UNITED STATES
NUCLEAR REGULATORY COMMISSION
WASHINGTON, D. C. 20555

OYSTER CREEK NUCLEAR GENERATING STATION, UNIT 1

AMENDMENT TO PROVISIONAL OPERATING LICENSE

Amendment No. 10
License No. DPR-16

FIGURE 6.2.1
OYSTER CREEK STATION
MANAGEMENT ORGANIZATION CHART

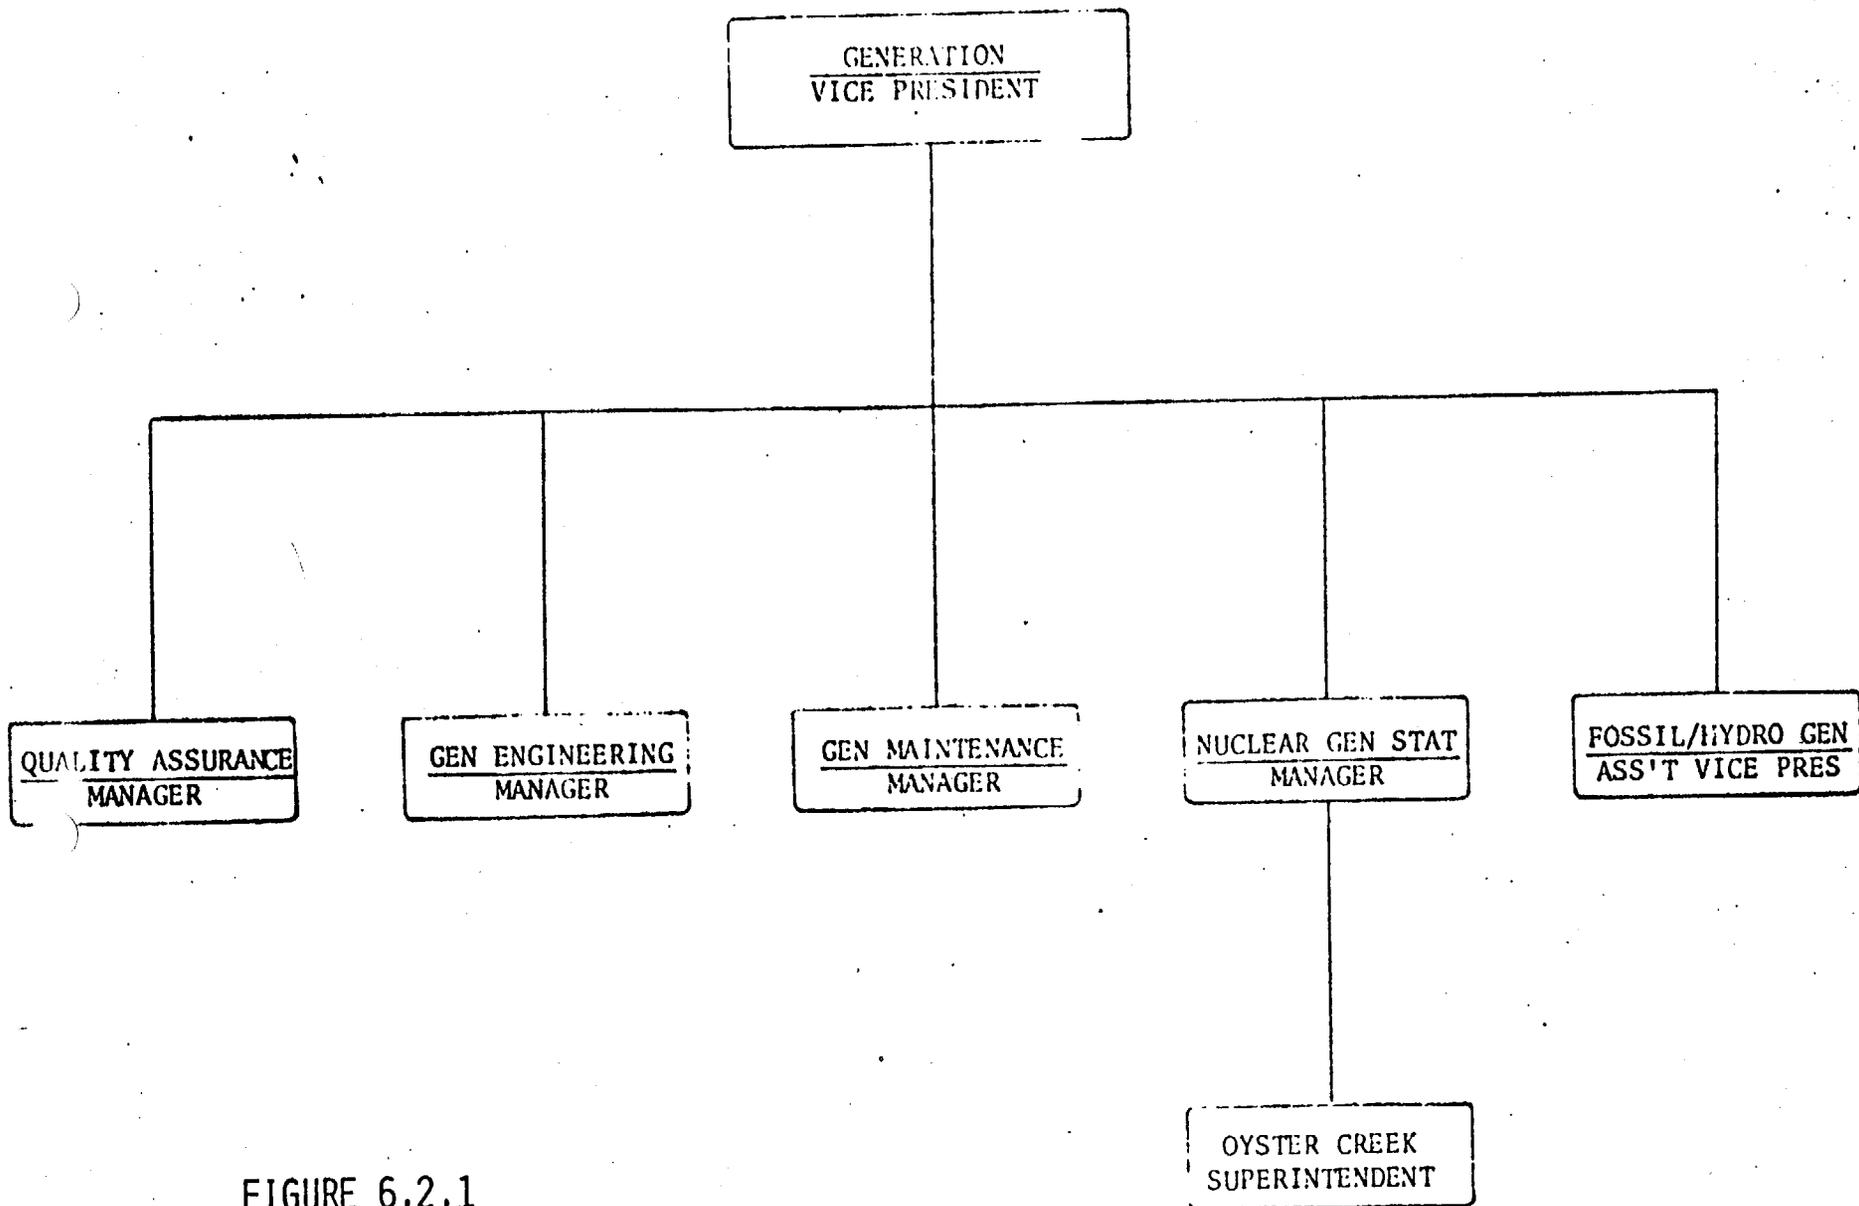
6.2.1 The offsite organization for facility management and technical support shall be as shown on Figure 6.2.1.

FIGURE 6.2.2

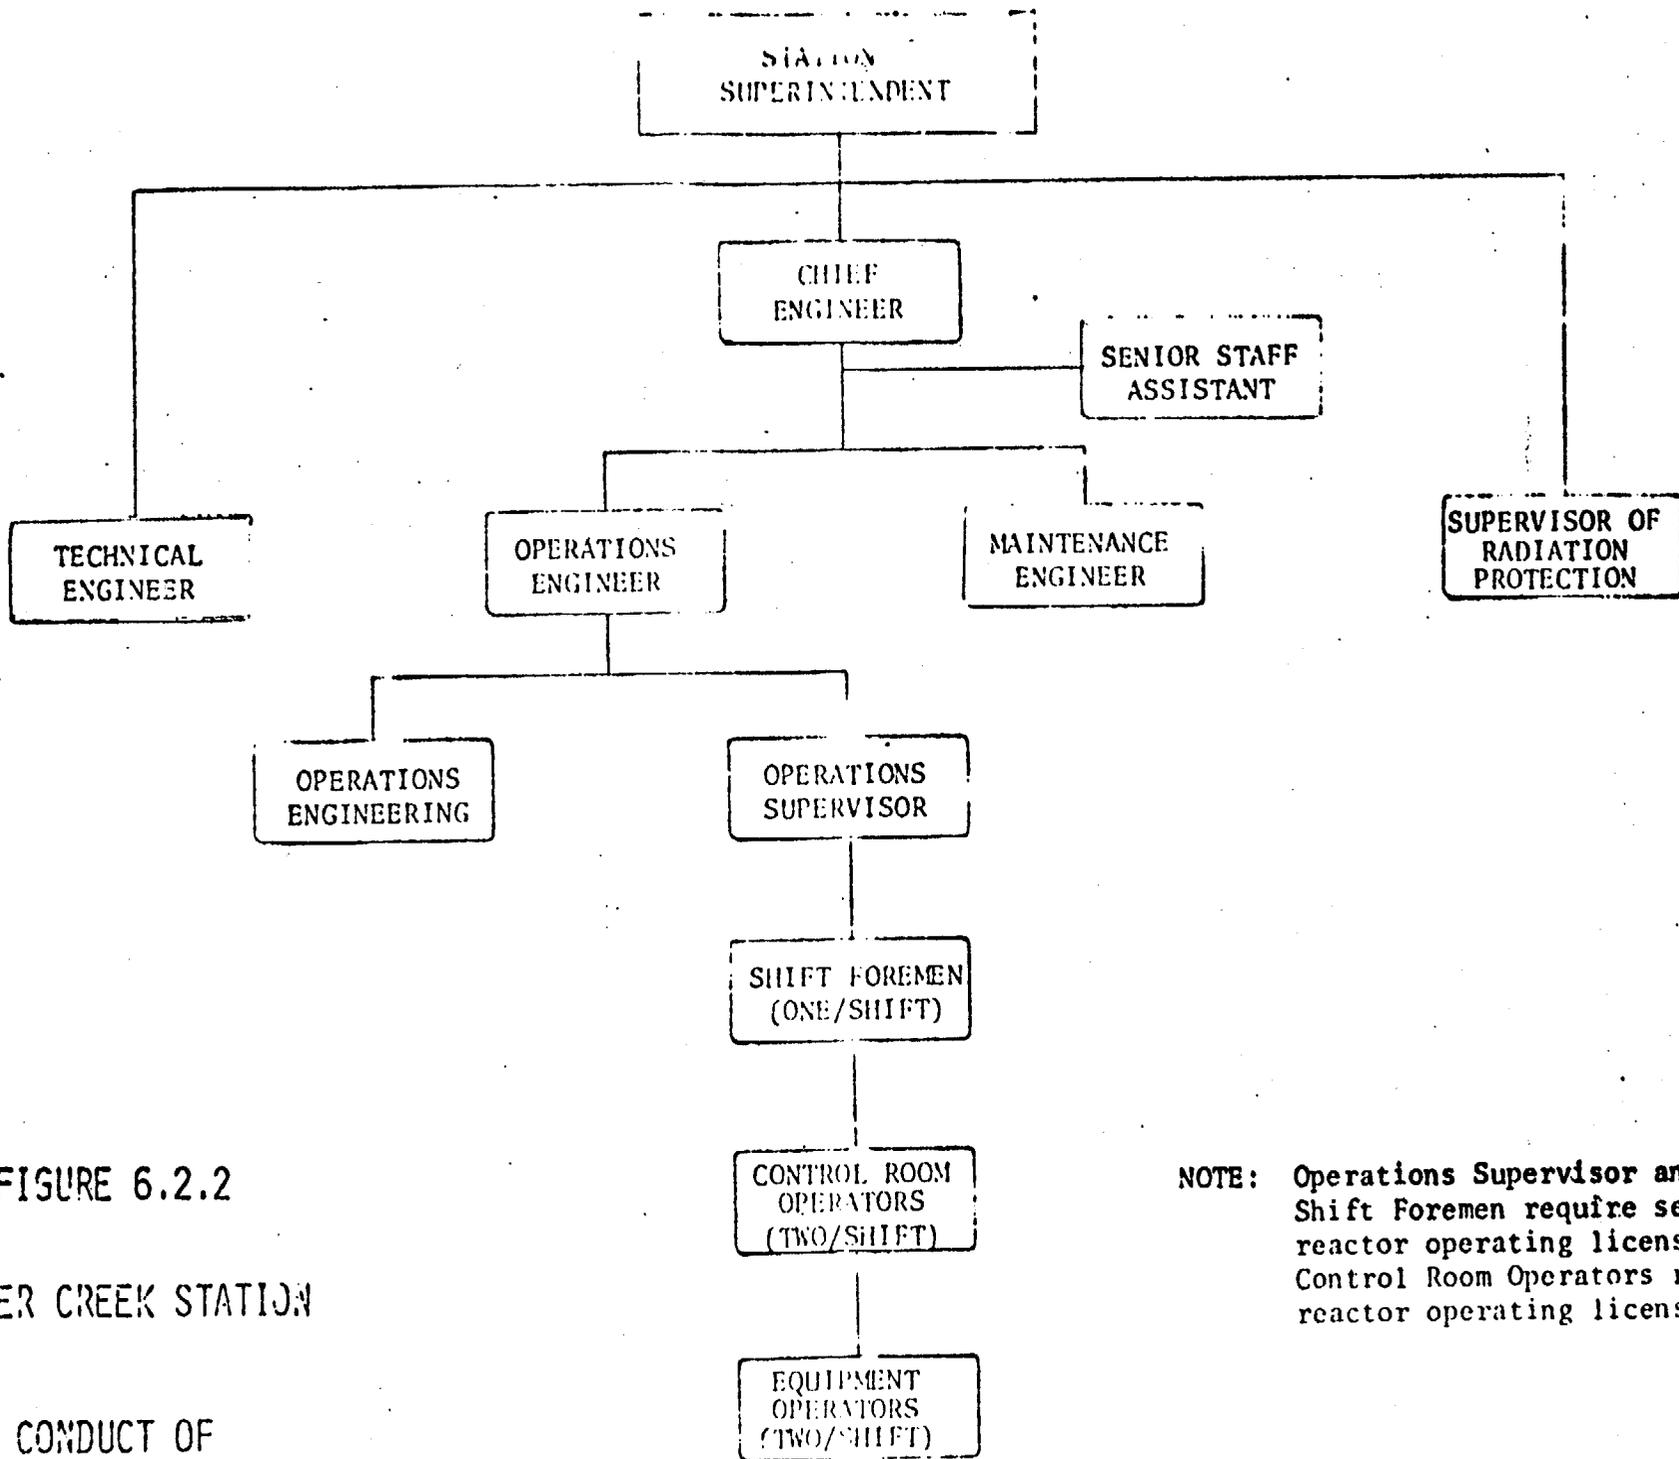
6.2.2 The facility organization shall be as shown on Figure 6.2.2 and:

- a. Each on duty shift shall include at least the shift staffing indicated on Figure 6.2.2.
- b. At least one licensed operator shall be in the control room when fuel is in the reactor.
- c. Two licensed operators shall be in the control room during all reactor startups, shutdowns, and other periods involving planned control rod manipulations.
- d. ALL CORE ALTERATIONS shall be directly supervised by a licensed Senior Reactor Operator who has no other concurrent responsibilities during this operation, or a licensed Reactor Operator will be assigned to manipulate the fuel grapple.
- e. An individual qualified in radiation protection measures shall be on site when fuel is in the reactor.

NOTE: Operations Supervisor and Shift Foremen require senior reactor operating licenses. Control Room Operators require reactor operating licenses.
